INA Service Info

Quieter engine

Changing from a rigid belt pulley to an Over-running Alternator Pulley

Models: Ranger

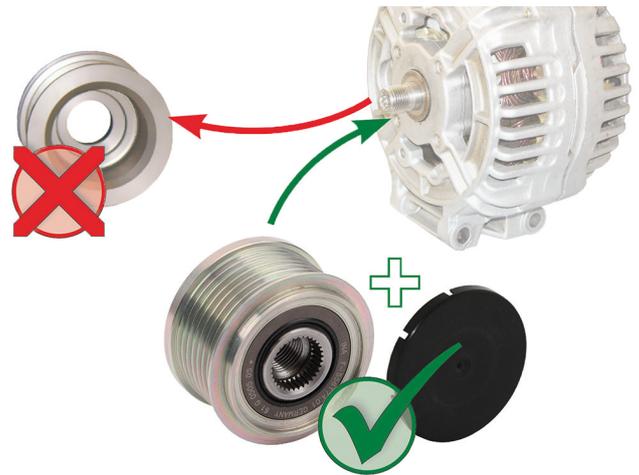
In the specified vehicles, uneven engine running may cause damage to the front end auxiliary drive. The rigid pulley on the alternator is frequently a cause of this.

The vehicle manufacturer is already upgrading the alternators from a rigid pulley to an Over-Running Alternator Pulley.

If a rigid pulley is still installed, it should be replaced by the Over-Running Alternator Pulley 535 0128 10. In addition, all components of the front end auxiliary drive must be checked to ensure that they are functioning correctly and also replaced, if necessary.
